### SERVICE BULLETIN SB-011323-A

ID NUMBER & REVISION: SUBJECT: RELEASE DATE: EFFECTIVE DATE: SUPERSEDES NOTICE:	SB-011323-A Engine Wire Harr 19 January 2023 19 January 2023 N/A	ness Installation		
AIRCRAFT AFFECTED:	MAKE & MODEL	ICON A5		
	SERIAL NUMBER	<b>S:</b> 00002 - 00136, 001 00152 - 00159, 0016		00146, 00148 – 00150, 163, 00166, 00170
<b>REQUIRED ACTION:</b>		-		I wire harness for proper
	installation on th and resecure the	• • • • •	nstall	ed, remove the cable ties,
TIME OF COMPLIANCE:	At the next servio	e interval		
<b>REVISION HISTORY:</b>	A Initial Release	e		
LEVEL OF CERTIFICATION REQUIRED (any level chec	□ Pilot/O : <b>ked</b> □ LSA Re	wner pairman – Inspection	$\boxtimes$	A & P Certified Repair Station
can perform task):		pairman – Maintenance	$\boxtimes$	Manufacturer

It was recently discovered that the Kevlar insulated, or spiral wrapped engine wire harness were not properly secured to the cable tie mounts near the intake plenum and throttle body. There is a specific installation that properly secures the wire harness to the engine, ensuring the wire harness remains wrapped during engine operations. Failure to have the insulated wire harness properly secured coul

Figure 1 Kevlar Insulation

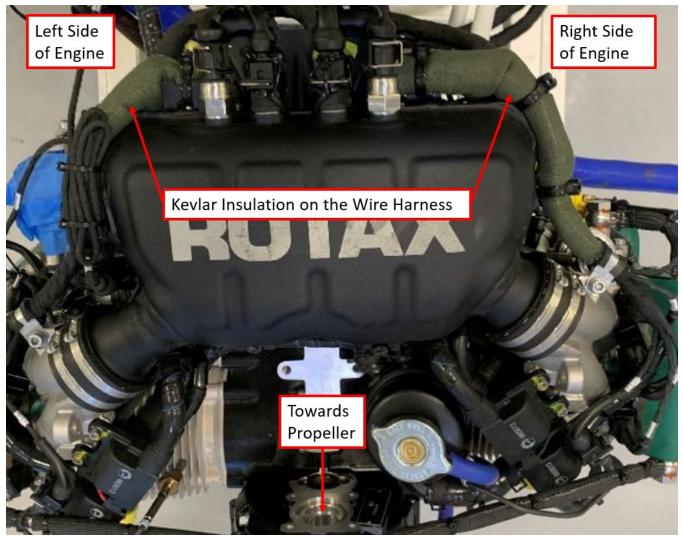
- 2. Locate the Kevlar insulated or spiral wrapped wire harness at the front (away from the propeller) of the engine.
  - a. See Figure 1

- 3. Inspect the Kevlar insulation or spiral wrap for any evidence of chaffing such as witness marks, tears, or discoloration.
  - a. If any evidence is present, contact ICON Aircraft.
- 4. Inspect any exposed wire harness wires for damage such as bare wire, discoloration, or cuts in the wire.
  - a. If any damage is present, contact ICON Aircraft.
- 5. Inspect that the installation of the wire harness is correctly secured to the cable tie mounts.

Figure 2 Right Side Kevlar on Top

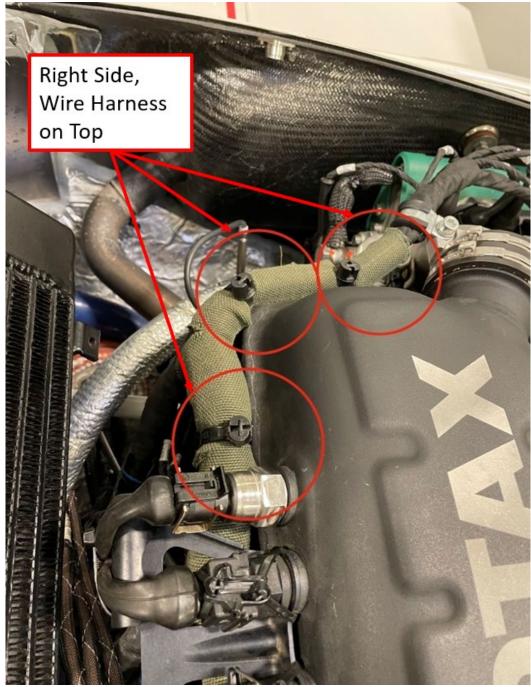
- a. At the right side of the engine, the wire harness shall be secured on top of the three cable tie mounts.
- b. At the left side of the engine, the wire harness shall be secured below the first cable tie mount (located below the engine wire harness connectors).
- c. At the left side of the engine, the wire harness shall be secured on top of the second cable tie mount.
- d. See Figures 2 through 4.
- 6. If the installation is not as shown in Figures 2 through 4, remove the five (5) cable ties at the cable tie mounts and secure as described in steps 7-9.
- 7. At the right side of the engine, position the wire harness on top of the cable tie mounts and secure with three (3) cable ties.
  - a. See Figure 2

Figure 3 Left Side Kevlar on Bottom

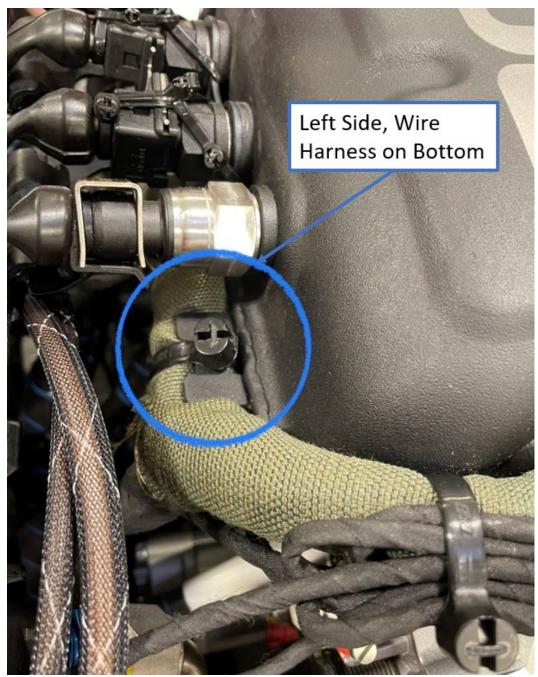
- 8. At the left side of the engine, position the wire harness below the cable tie mount (below the engine wire harness connectors) and secure with one (1) cable tie.
  - a. See Figure 3

Figure 4 Left Side Kevlar on Top

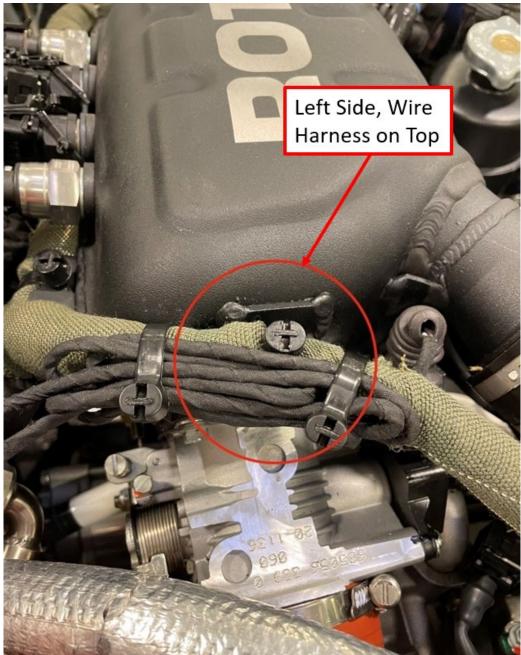
- 9. At the left side of the engine, position the wire harness on top of the cable tie mount and secure with one (1) cable tie.
  - a. See Figure 4
